**U.S. Environmental Protection Agency, Region IX**  
**Response to Comments**  
**on the**  
**Draft 2019 NPDES Permit (AS0020028) for the American Samoa Terminal**

Nicholas F. King, Jr., Terminal Manager of Pacific Energy SWP Limited (“Pacific Energy”), provided comments on EPA’s draft NPDES permit in a letter emailed on July 5, 2019. The following are EPA’s responses to Pacific Energy.

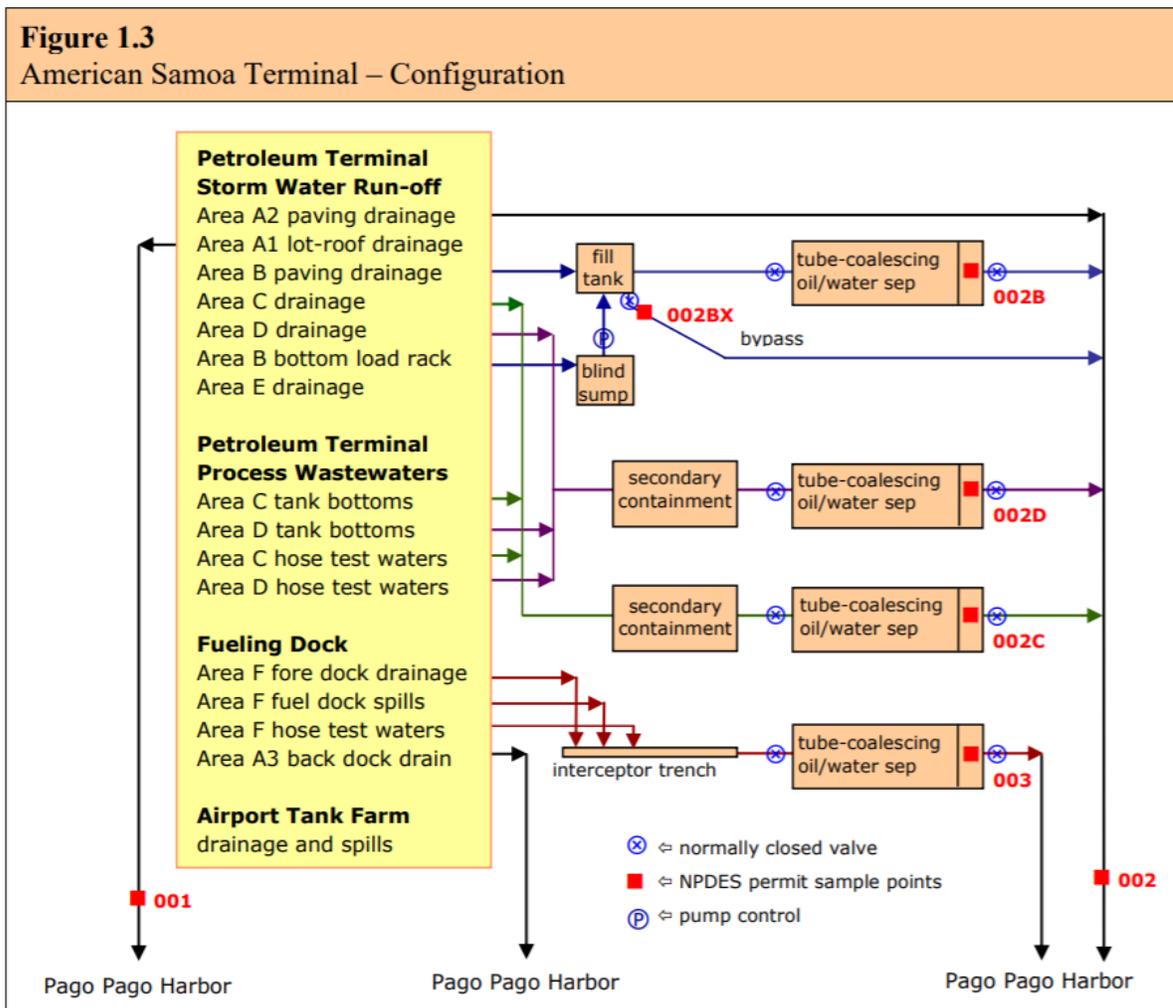
**Comment #2: Monitoring Requirements for Area B (Sampling Point ID 002B & 002BX)**

Area B does not receive significant rainfall on the catchment area. Area B is provided with near-total overhead cover. Overhead cover is provided for the convenience of loading

tanker trucks in a rain-free environment, and to keep rainfall from carrying contaminated water to the receiving water in the event of an accidental spill event.

Area B does not generate process wastewater (A(i) & A(ii) above), because there is no planned, intentional, or regular operations that results in the regular discharge of fuel, or discharge of water that has been contact with fuel, or discharge of water that has been in contact with surfaces previously in contact with fuel. Thus, there is no regular discharge of the commingled fluid of stormwater (rainfall) plus process wastewater that US EPA defines as “process wastewater” from Area B.

Based on the near-total overhead cover and intended purpose and use of Area B at the Main Terminal facility, Pacific Energy considers that the sampling, analyses, and reporting requirements for Area B, as shown in Table 3 of the Draft Permit and Table 8a of the Draft Fact Sheet, are excessive and do not serve a justifiable purpose for monitoring and reporting for regular discharges of process water or commingled stormwater.

As written with regard to Area B, Pacific Energy interprets the Draft Permit and Draft Fact Sheet to impose monitoring requirements for Area B as an on-going check for unintentional and unpredictable accidental spills, and not as a monitoring requirement for regular discharge of the commingled fluid defined by US EPA as “process wastewater”. As we interpret it, Pacific Energy disagrees with the imposition of monitoring requirements for Area B.

Pacific Energy requests that US EPA provide a detailed explanation of the reasoning and rationale for the sampling, analyses, and reporting requirements imposed for Area B, to include US EPA’s interpretation of how the operation of Area B results in a regular discharge to the receiving waters.

**Response to Comment #2:** EPA understands that washdown may not be truck-related and has removed the word ‘truck’ from truck washdowns from the description of Outfall 002 (on page 4) in the Fact Sheet to minimize confusion. Therefore, the revised

statement is: “Area B drains the loading rack which may contain washdowns and spills associated with loading fuel into delivery trucks, and commingled stormwater runoff.”

The discharge from Area B loading rack is a permitted discharge and must be sampled in accordance with the conditions in the permit. Numerous inspections<sup>1</sup> have been conducted by EPA over the years that demonstrate and confirm that Area B does generate process wastewater.

Based on reports from EPA’s inspections during March 2008, April 2009, and September 2010 that were subsequently sent to Pacific Energy, the inspector noted Area B drainage as follows: “Spills, wash down, and drainage from the bottom fill loading rack collect into a blind sump tank through floor drains. The sump contents are pumped into a pre-filler surge tank. Storm water run-off from the surrounding paved areas also drain into the surge tank, which is operated to release through an oil water separator. There is normally closed valving into and out of the oil water separator and out through a bypass line. The Area B oil/water separator discharges to the facility storm water culvert leading to the harbor, which is designated in the permit as NPDES-002. The Area B oil/water separator effluent is designated in the permit as NPDES-002B and the bypass line is designated as NPDES-002BX.”

It is EPA’s understanding that spills routinely occur during tanker truck loading, they are not unpredictable. To facilitate understanding of Area B drainage, the 2008, 2009 and 2010 inspection reports included a schematic of the generation and handling of facility wastewaters that has remained substantially unchanged, labeled as Figure 1.3 below.
